Item Name: Replacement Skidtube, Low & High Gear with Standard Wearplates Fits LH or RH

DRAWING NO. D2650	TITLE 206/407 SKIDTUBE ASSEMBLIES	REV. F	DART AEROSPACE LTD ENGINEERING ORDER		D.E.O. NO. D2650-F-1	SHEET NO. SHEET 1 OF 1	SCALE NTS
DRAWN <i>[Signature]</i>	CHECKED A.P.	MFG. APPR. <i>[Signature]</i>	APPROVED <i>[Signature]</i>		DE APPR. <i>[Signature]</i>		
DATE 12.10.12	DATE 12.10.22	DATE 12.10.22	DATE 12.10.22		DATE 12.10.22

CHANGE C'BORED WELDED CROSSBOLT SPACERS TO SWAGED SPACERS

AMENDMENT TO DETAIL B
NOT TO SCALE

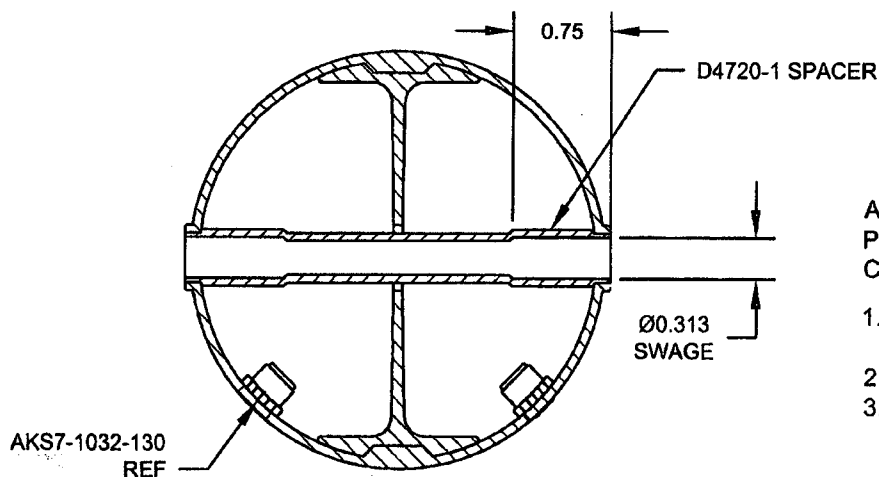
C'BORED HOLES ARE **NOW SWAGED** PER DETAIL G BELOW. FOR THE Ø0.375 HOLE THAT IS NOT C'BORED, WELD PER DETAIL D OF DWG (SEE AMENDED DETAIL B FOR REFERENCE).
